LONGHORN ARMY AMMUNITION PLANT KARNACK, TEXAS

ADMINISTRATIVE RECORD

***LONGHORN ARMY AMMUNITION PLANT
KARNACK, TEXAS
ADMINISTRATIVE RECORD – CHRONOLOGICAL INDEX***

Figure 3-1

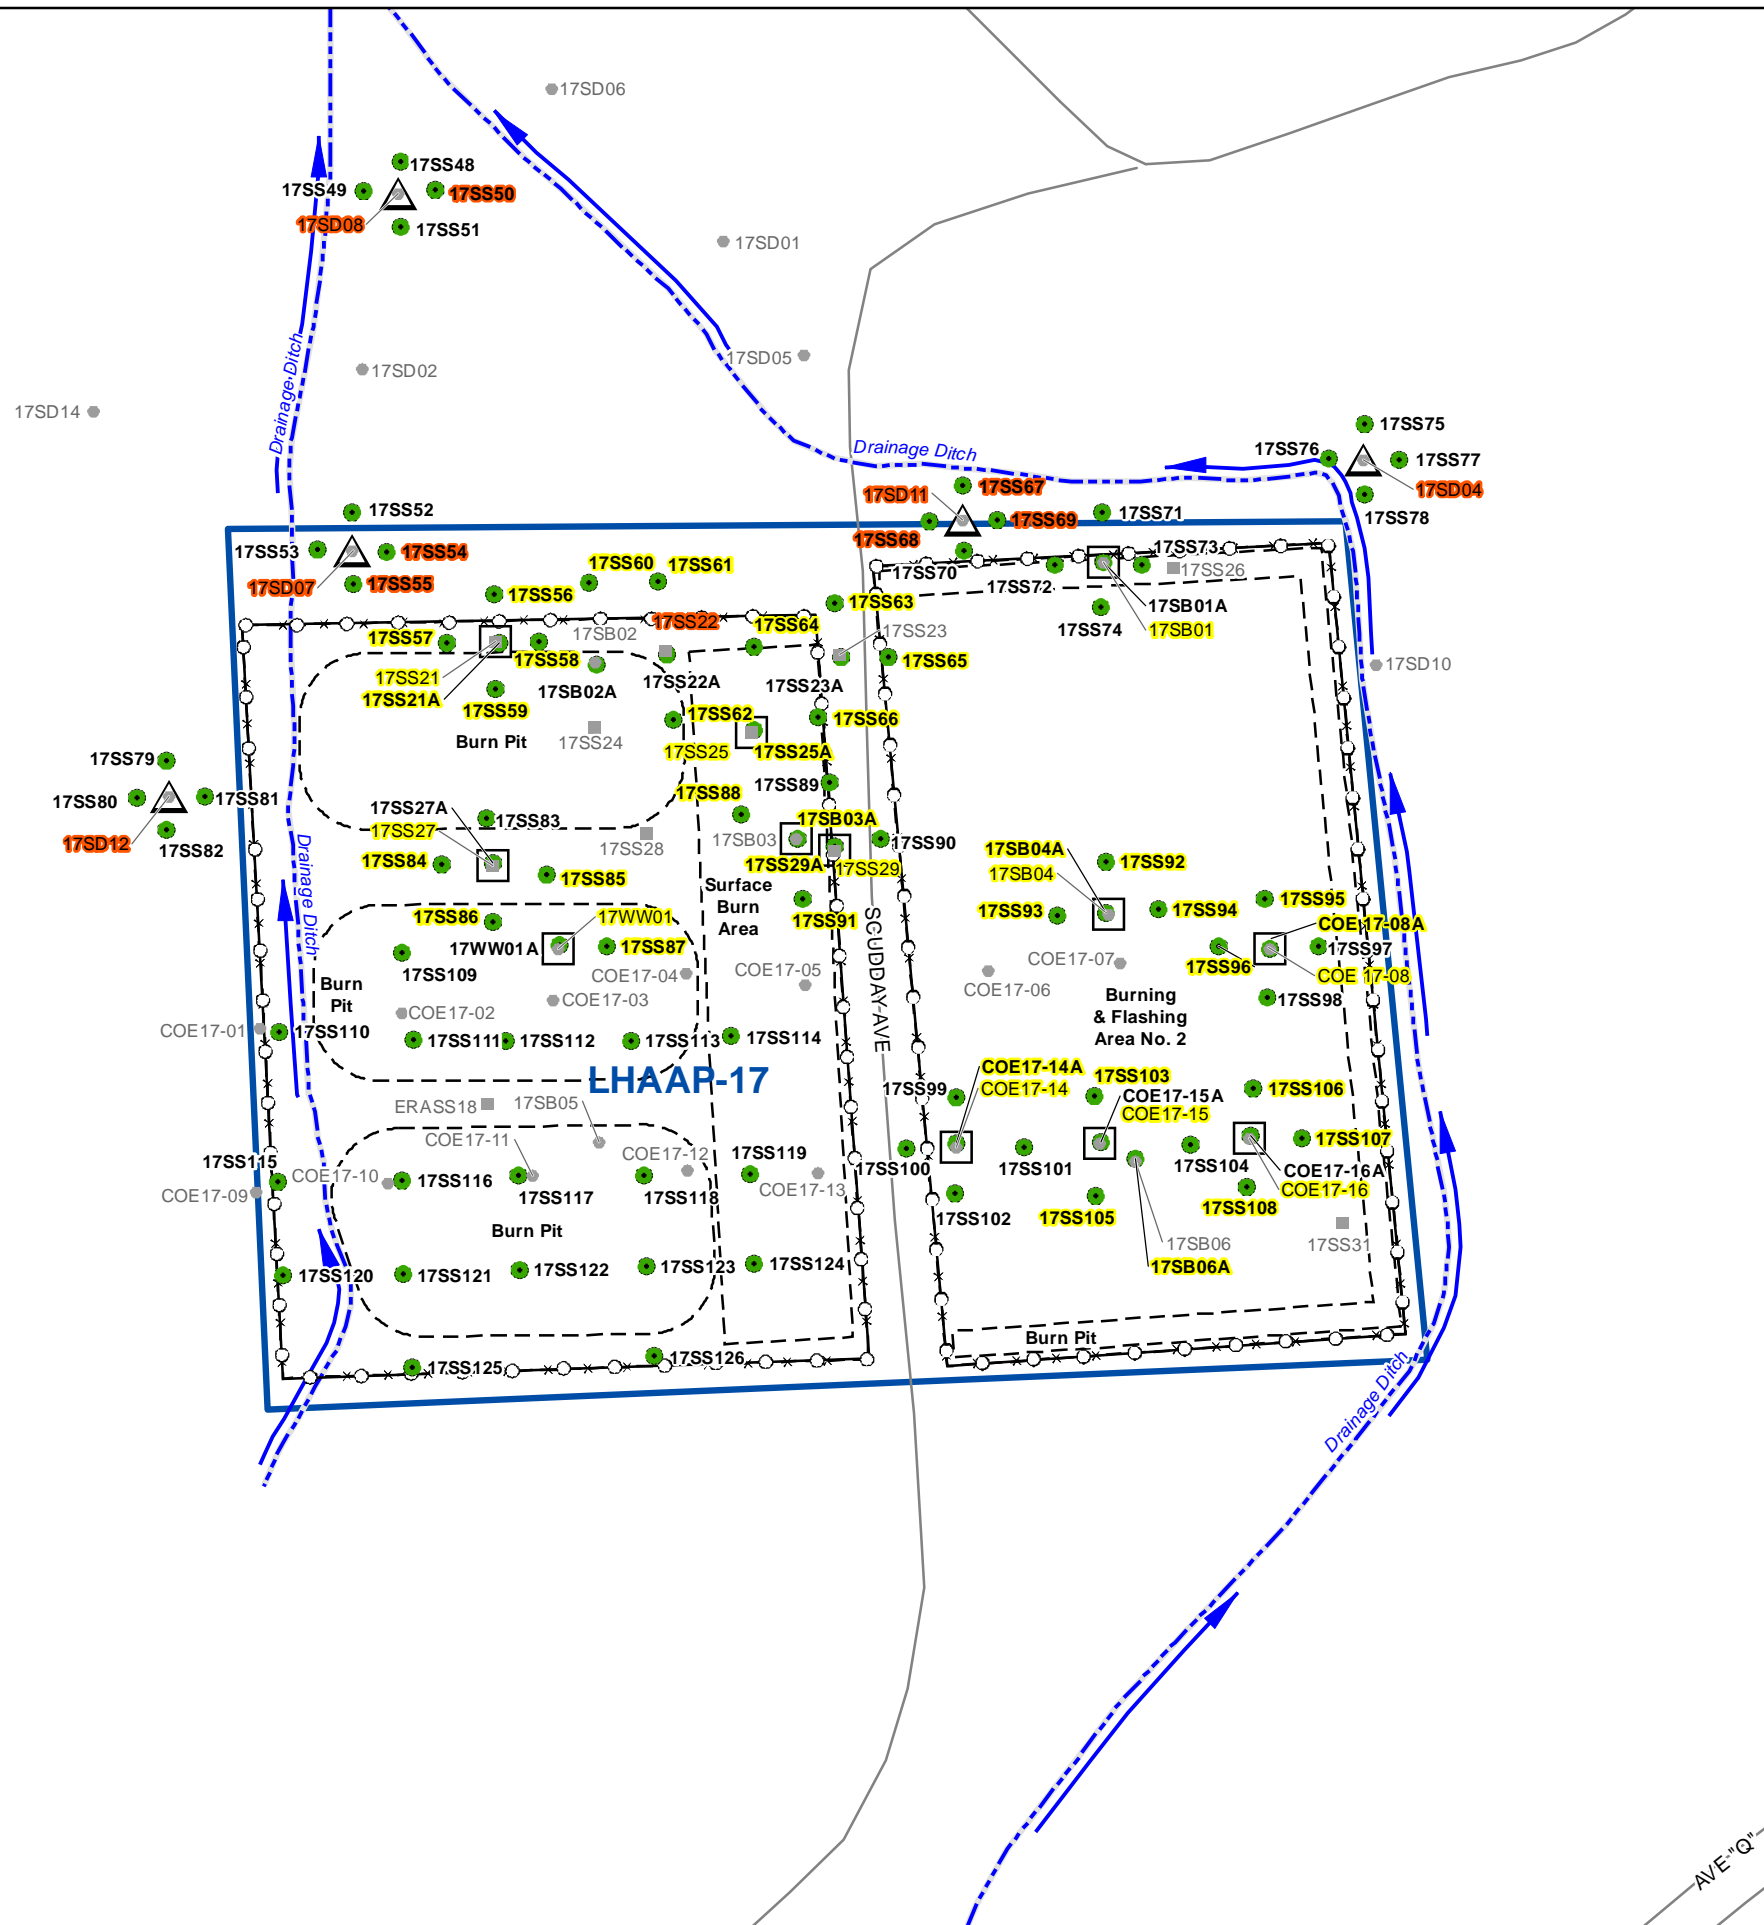
2.	Page 1-6, Section 1.5	Bhate, 2018 should be Bhate, 2018b	C	Text will be revised to correct the reference as suggested.	
3.	Table 1-3	Table 1-3 indicates that 5 soil sample locations are above the cleanup levels for Barium; however, Figure 3-1 indicates 11 soil sample locations. Which is correct?	C	Table 1-3 was duplicated from Table 2-11 of the Final ROD, and the sample locations referred to in the ROD table were the known exceedances at that time. Figure 3-1 shows the exceedances identified following the conclusion of the PDI sampling. Table 1-3 has been revised to remove the Sample Location column since the information in it is not referenced in the document, and Figure 3-1 has been revised to show 17SS22 as a barium exceedance location.

7.	Page 4-1, Section 4.2	The text refers to Figure 2-1, which should be Figure 3-1. EPA recommends adding the concentrations of explosives and barium that exceeded the health criteria to the Figure.	C/D	The text reference has been revised to refer to Figure 3-1. Each location shown as highlighted may have up to 3 different COC concentrations exceeding the health criteria at one or more depths. Adding the data (COC, depth, and concentration for each

Comment No.	Section, Page ref.	USEPA Comment	C, D, E, or X¹	Response	A or D²
				exceedance) to each location would make the figure extremely difficult to read and would obscure the primary purpose of showing the overall pattern of the soil areas requiring excavation. The title of the figure has been revised to “Soil Sample Locations with Concentrations Exceeding the Cleanup Levels” to clarify the purpose. A reference to Table 3-1 has been added to the legend of Figure 3-1.

FIGURE 7-1
GROUNDWATER EXTRACTION SYSTEM LAYOUT
REMEDIAL DESIGN / REMEDIAL ACTION
WORK PLAN
LHAAP-17
LONGHORN ARMY AMMUNITION PLANT
KARNACK, TEXAS

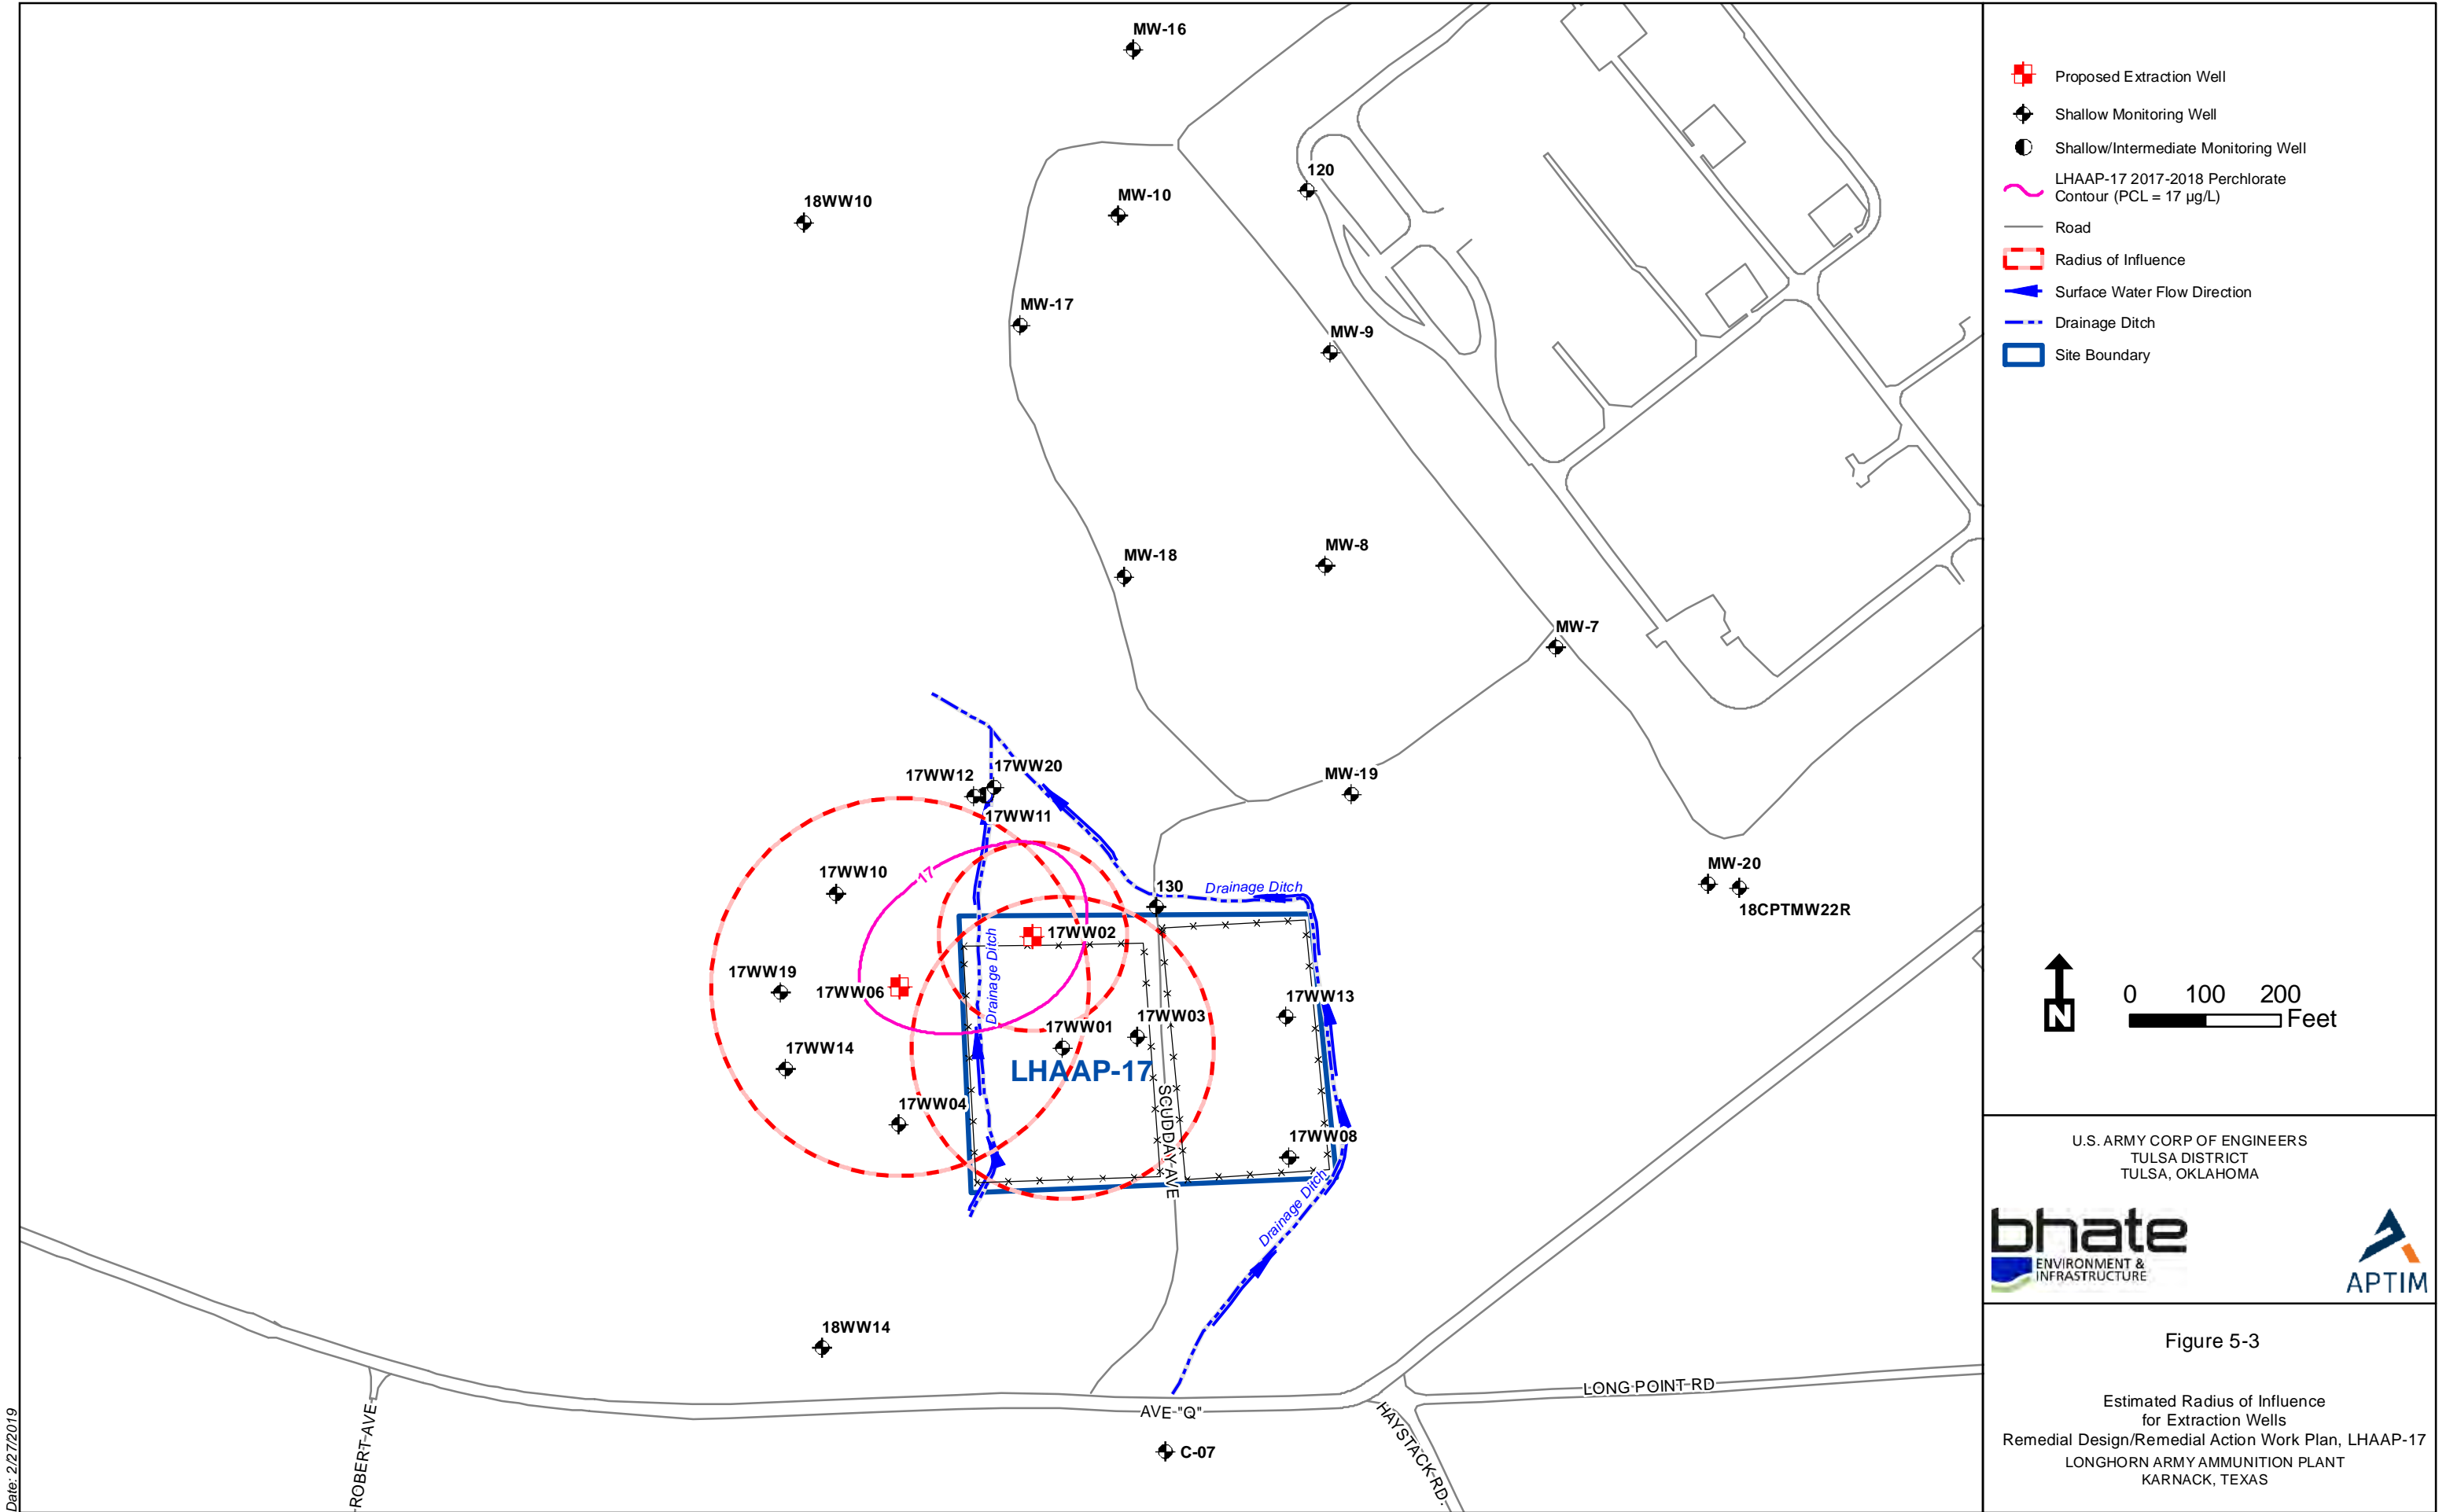
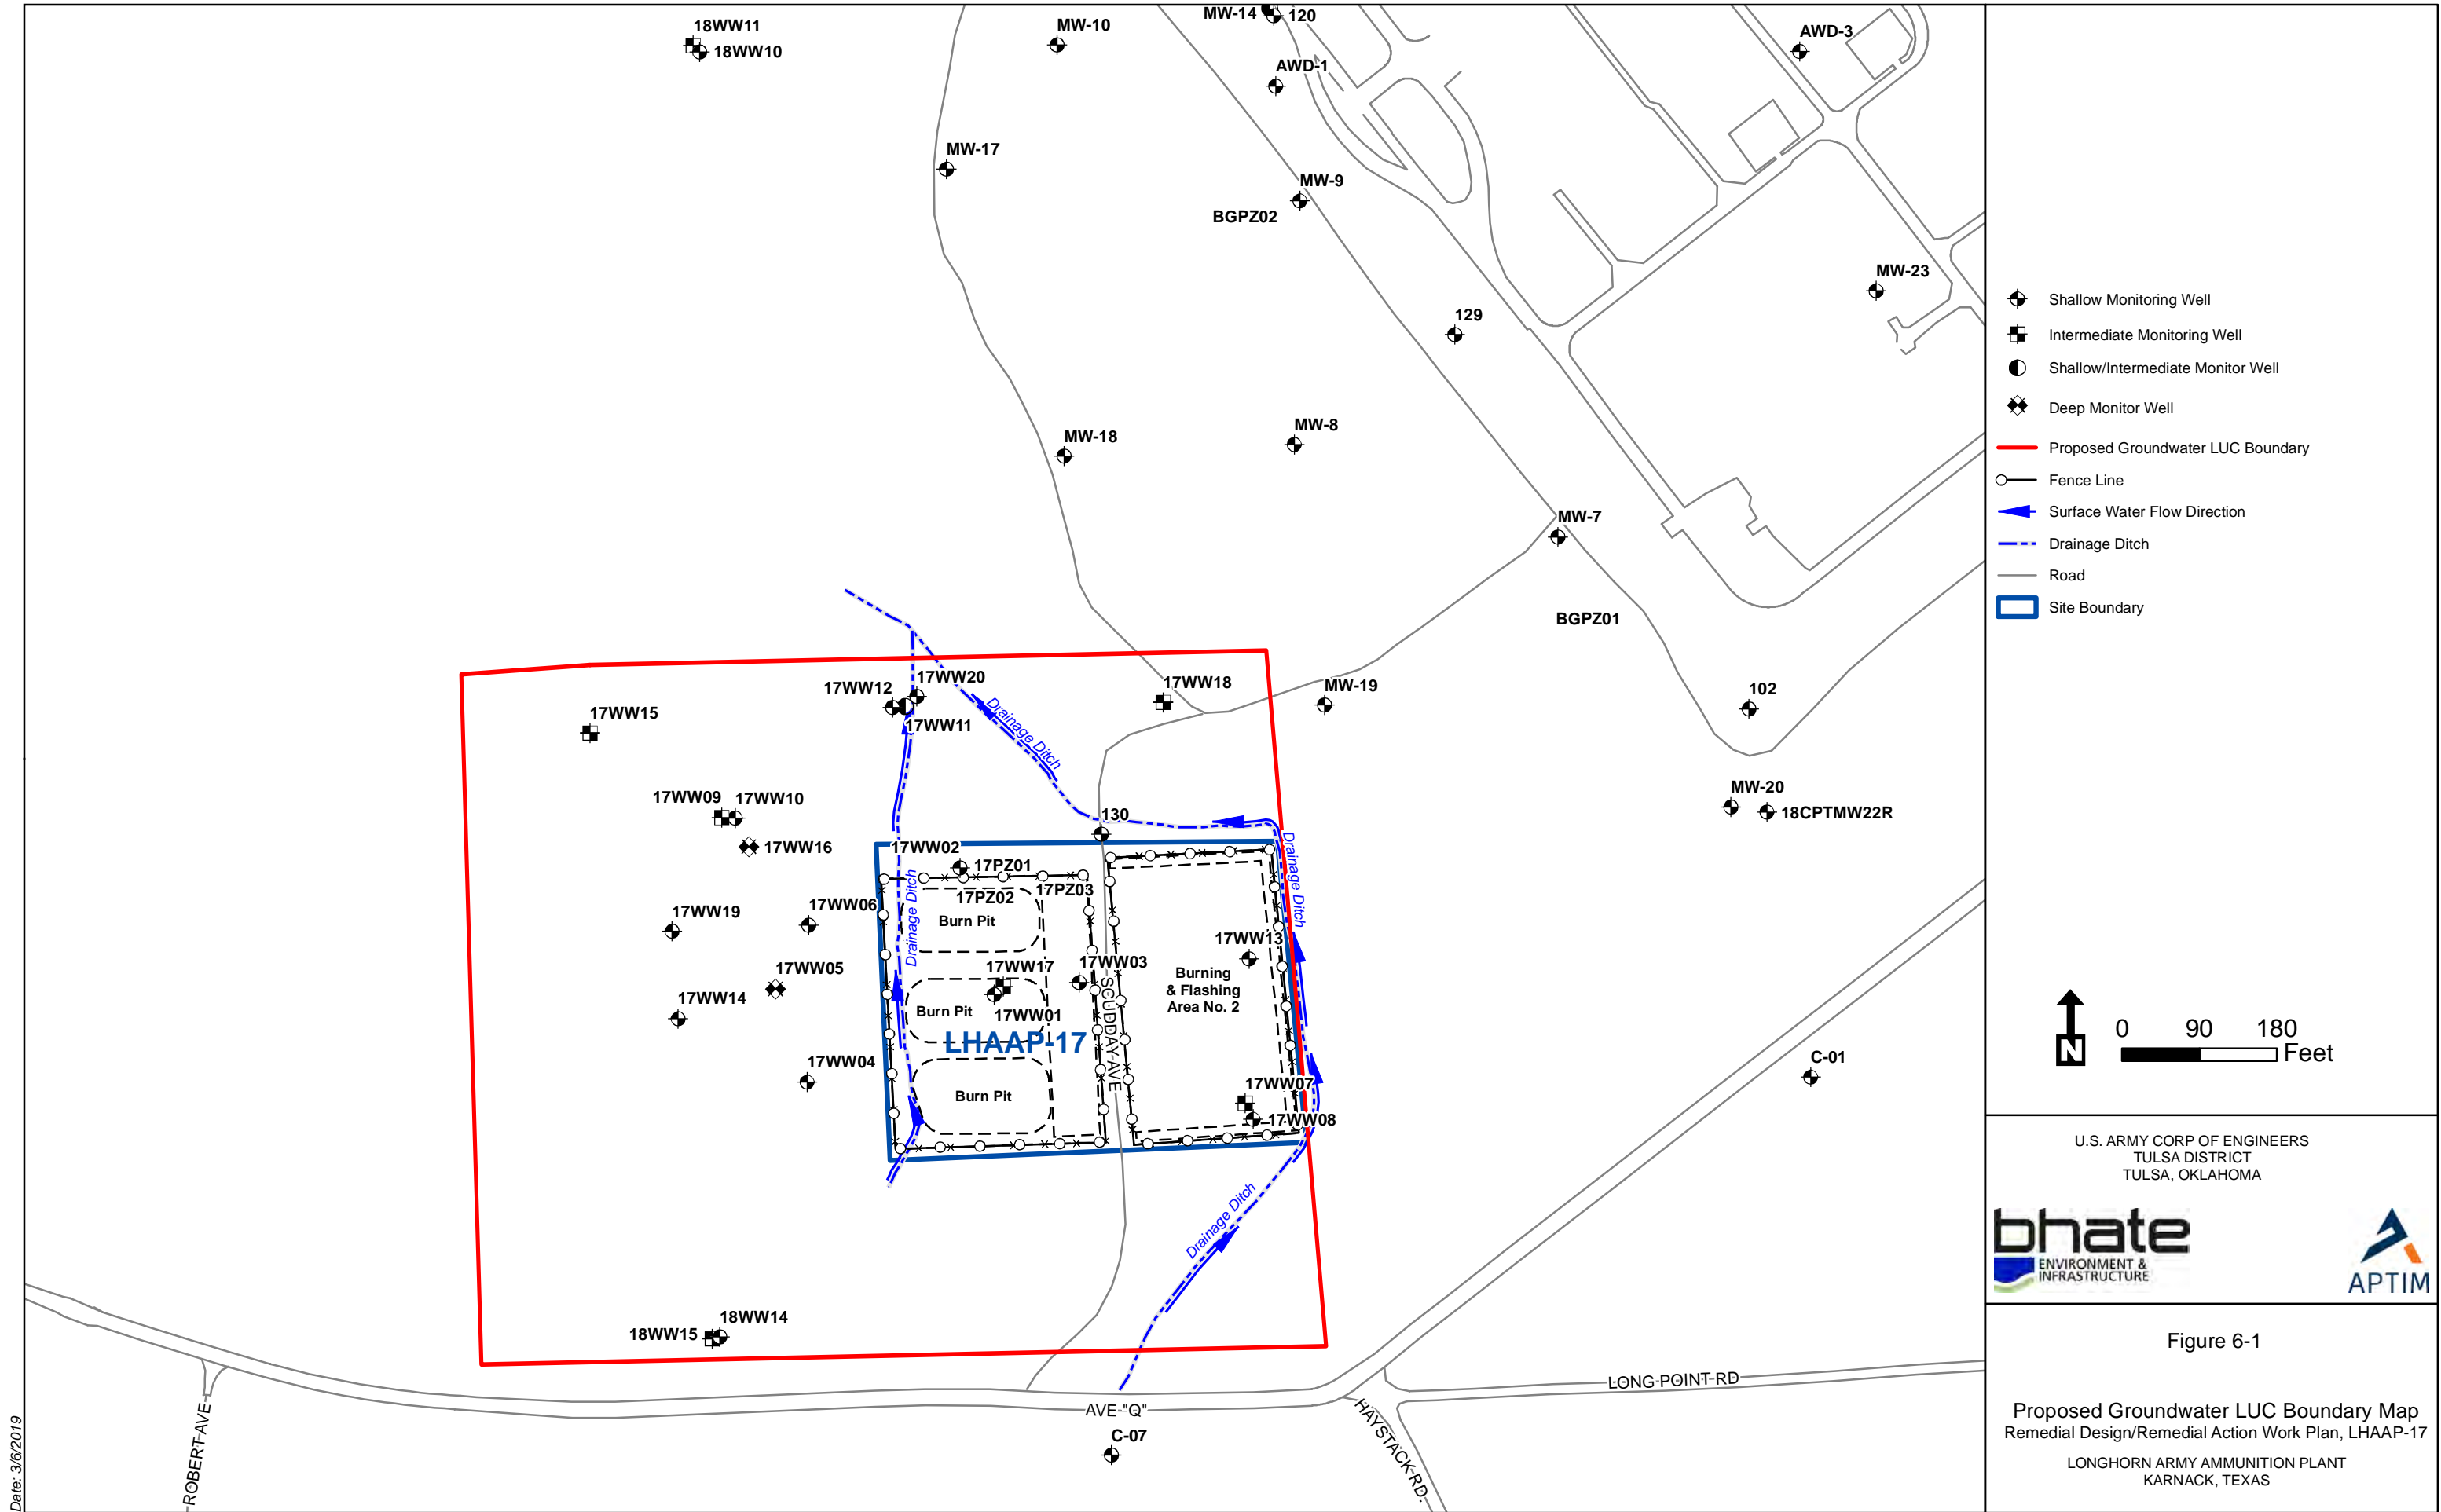
21.	Figure 7-1	Add 17WW01.	C	17WW01 has been added as a possible extraction well as requested.	
22.	Figure 8-1	Include all wells and change the color, symbol, or highlight for MNA wells. Don't hide non-MNA wells.	C	Figure 8-1 has been revised as requested.
